BGS 3388 - RFI Repair Bldg 518 Exterior -

PROJECT TITLE:
SQUADRON OPERATIONS/AGU
BANGOR INTERNATIONAL AIRPORT
AIR NATIONAL GUARD
BANGOR, MAINE

DRAWING TITLE:
GROUND FLOOR PLAN

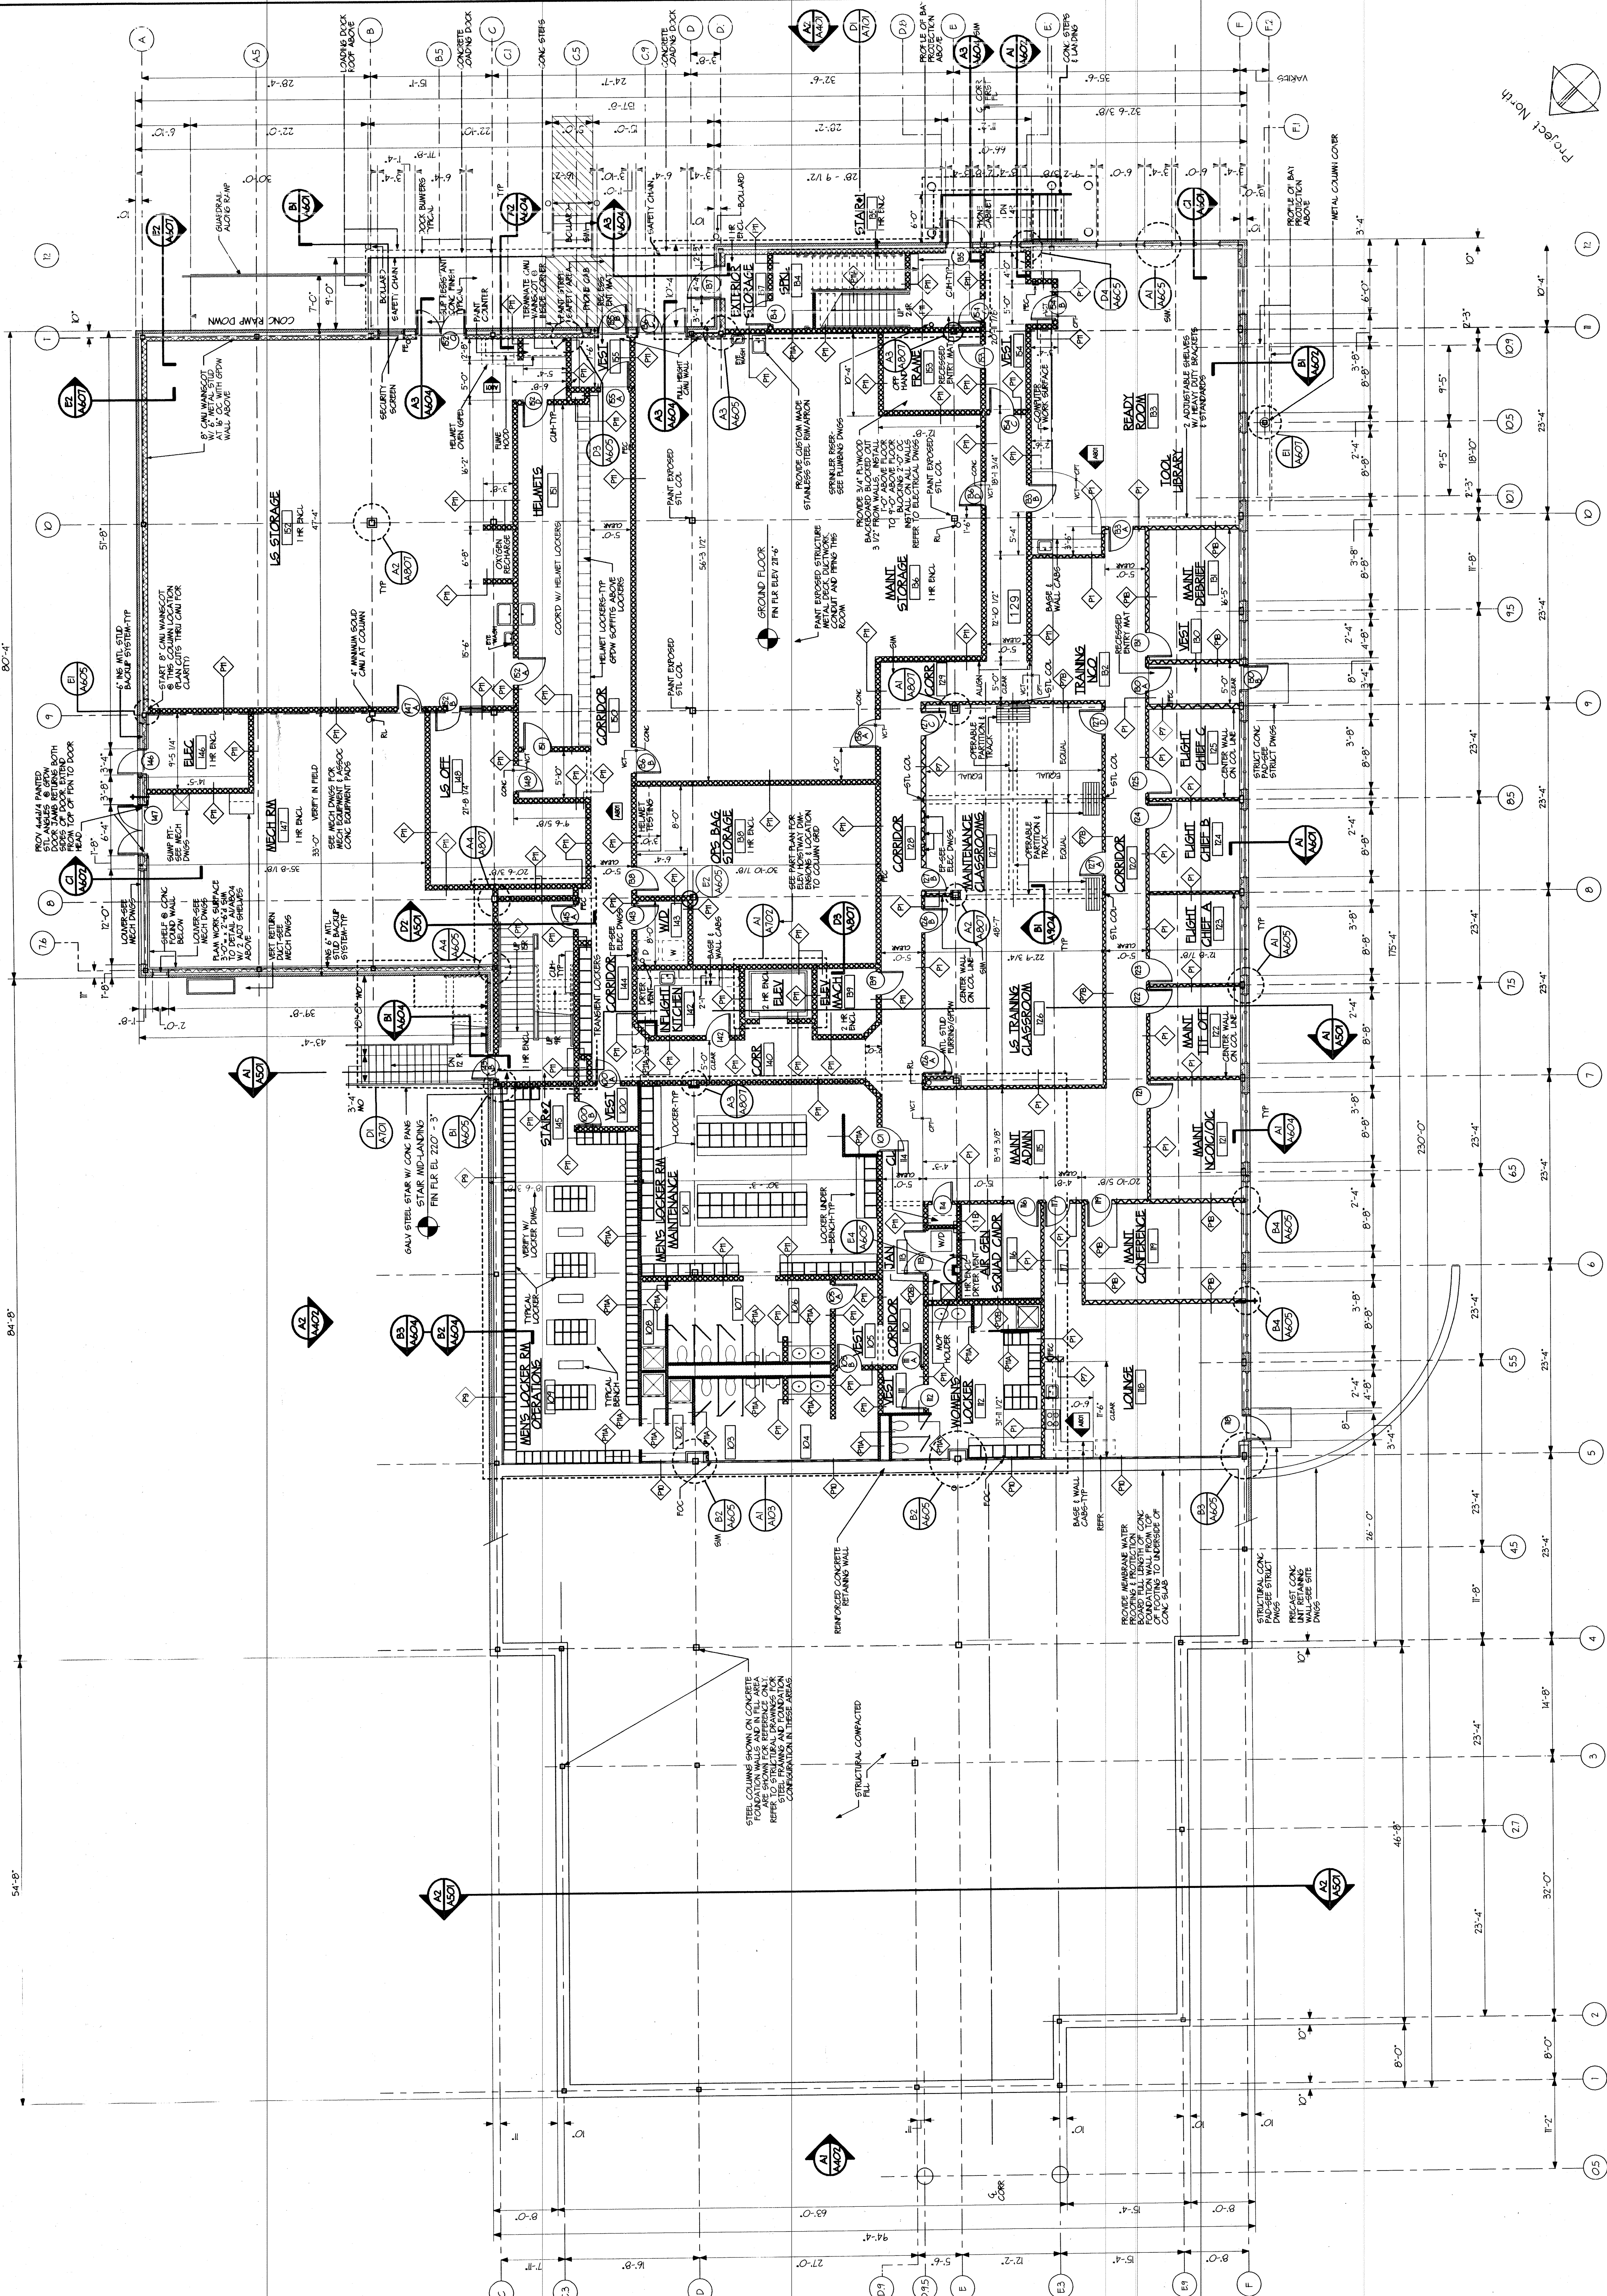
Q1. Provide plan view of the building to determine the dimensions of the exterior building perimeters that will require the application of the masonry sealant.

A1. Provided as two attachments

-BGS3388 Question 1 answer part 1 A101 Ground Floor Plan
